**Project #22-056  
Mountainside Estates Subdivision Amendment  
Located at 1200 East 1400 North**

**REPORT SUMMARY...**

## MEMORANDUM TO PLANNING COMMISSION

DATE: Planning Commission Meeting of February 12, 2023  
FROM: Russ Holley, Senior Planner  
SUBJECT: Continued PC 22-056 Mountainside Estates Amendment

Figure 2 shows the proposed cross section of the upper and lower lots.

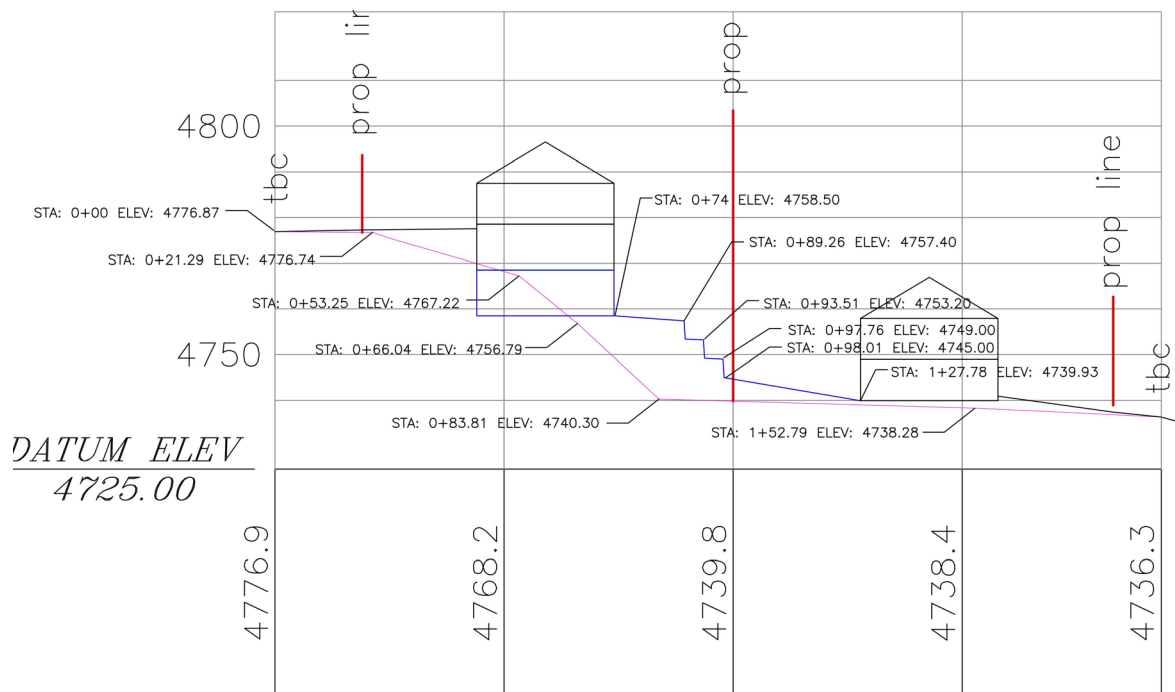
The LDC 17.30 street connectivity requirement ensures equitable traffic distribution, efficient utility/infrastructure networks, better walkability and the continuation of Logan City's historic grid patterns. This proposal does not request any changes to the already approved street grid patterns. It does propose that six (6) of the amended single family lots will now gain access from the upper existing 1300 North Street. 1300 North does not currently have sidewalk and park-strip along the northern edge adjacent to these proposed lots.

- a) Street trees along all streets provided every thirty (30) feet on center unless otherwise noted by the City Forrester.
9. All streets adjacent to or within the development shall be improved to current city standards and specifications. 1300 North shall have sidewalk and park-strip added to the north edge.

- 9) The north side of 1300 North shall be improved with asphalt, park strip, and sidewalk improvements pursuant to the dimensions in the City's Gridded/Connection/Residential Collector Street Cross Section and the City's design and land use standards.

**MOUNTAINSIDE ESTATES**  
**PHASE 2**  
PART OF THE NORTHEAST QUARTER OF SECTION 20  
TOWNSHIP 11 NORTH, RANGE 1 EAST  
SALT LAKE BASLINE AND MERIDIAN  
UTAH

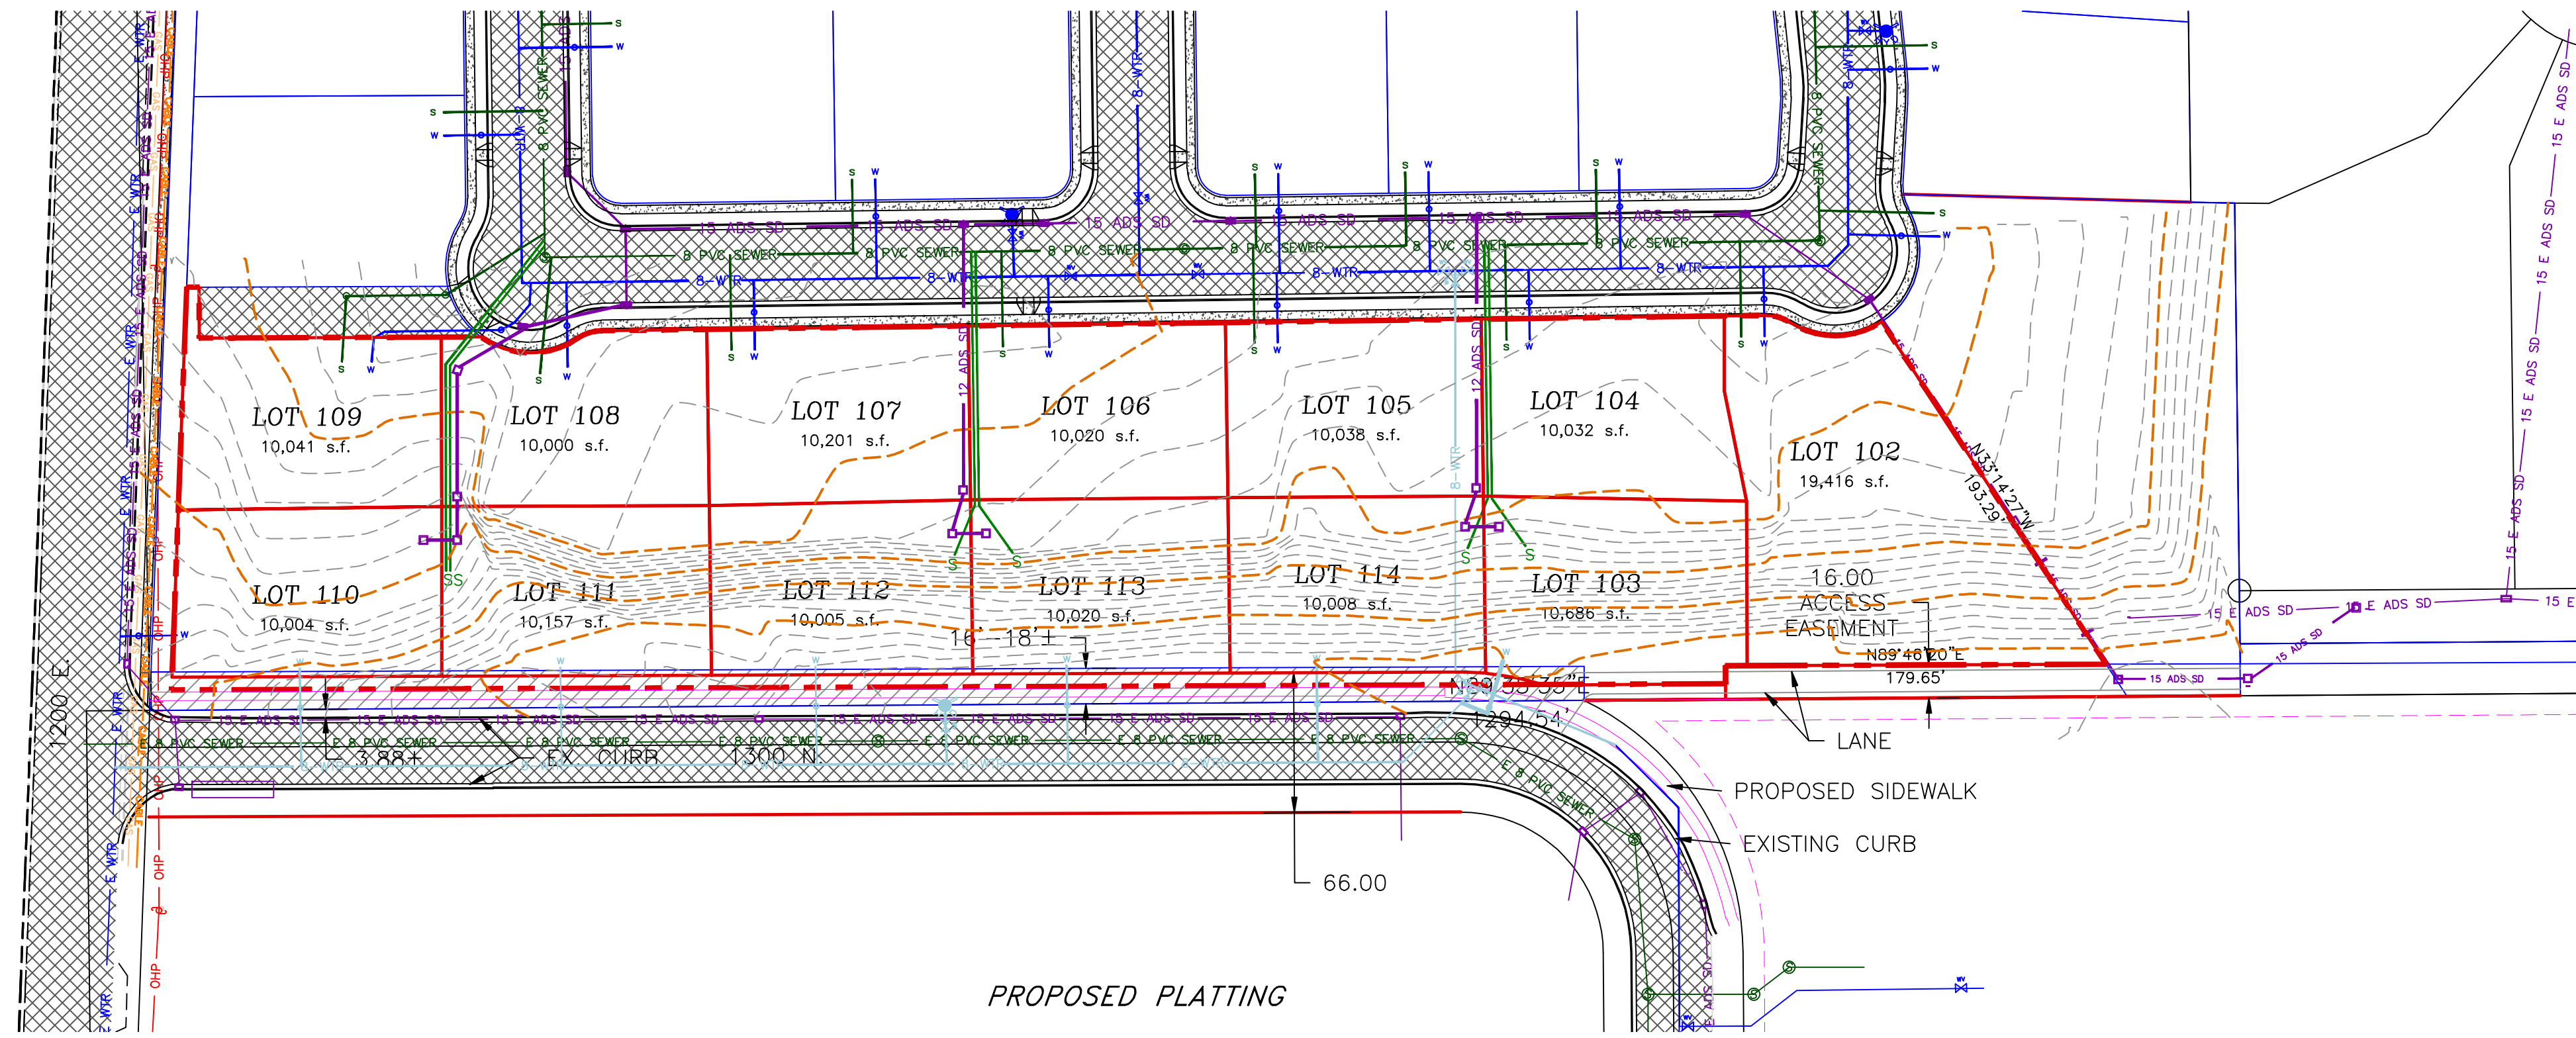
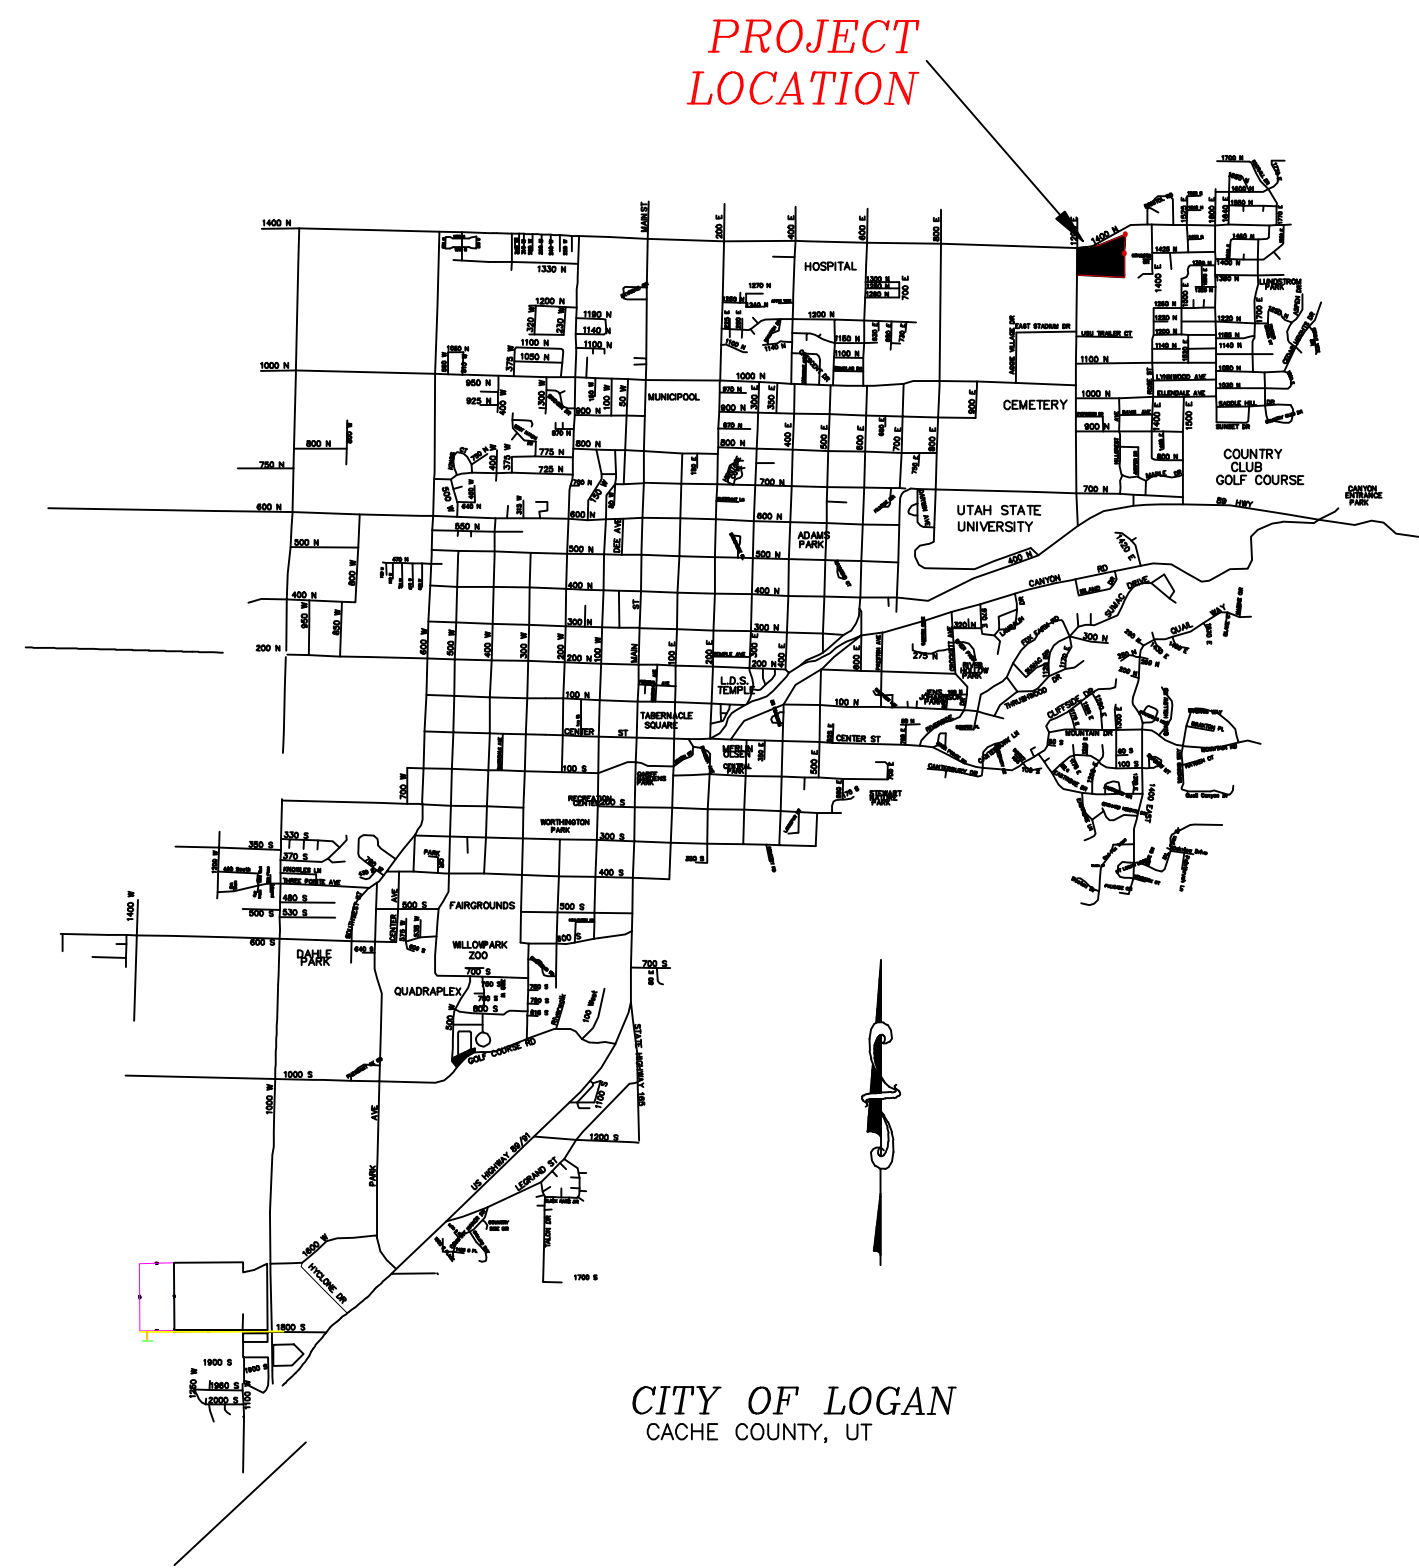
- c. *Engineering – contact 716-9160*
    - 1) An apparent gap in property ownership exists between the proposed lots and the 1300 North City right of way. The boundaries of this property do not appear to have ever extended across this gap. As a condition of approval, the gap or portion thereof will need to be obtained and dedicated to the City by the developer such that a minimum 66 foot right of way is achieved and constructed per the City's 66' road standard and any remaining property is added to the lots such that the lots are contiguous with the right of way.

- 2) A 10 foot Public Utility Easement shall be dedicated adjacent to the north side of the 1300 North right-of-way.
    - 3) An HOA entity separate from the Mountainside Estates Subdivision shall be created for the lots in the plan amendment. This separate HOA shall bear the responsibilities and obligations identified in the conditions of approval. The CC&R's for the HOA must be reviewed and approved by the City Logan.

- 11) Per section 17.29.060.A.2 only one driveway is permitted on a single family residential lot. As such, remove the proposed 16' access easement identified east of lot 103. If an existing easement exists through this area, a description of the easement, width, and recording information shall be included on the Final Plat and construction plans.
- 12) Provide a Storm Water Maintenance Agreement for review and approval by the City and recorded with County Recorder
- 13) Dedicate a 10' public utility easement along all property frontages to existing and planned City roads and a 5' public utility easement along all other property lines.
- 14) Sewer services shall be extended to all lots. Provide City with water shares or in-lieu fee for increased demand to City system. This requirement shall be per City Code and Utah Administrative Rule R509-519-7
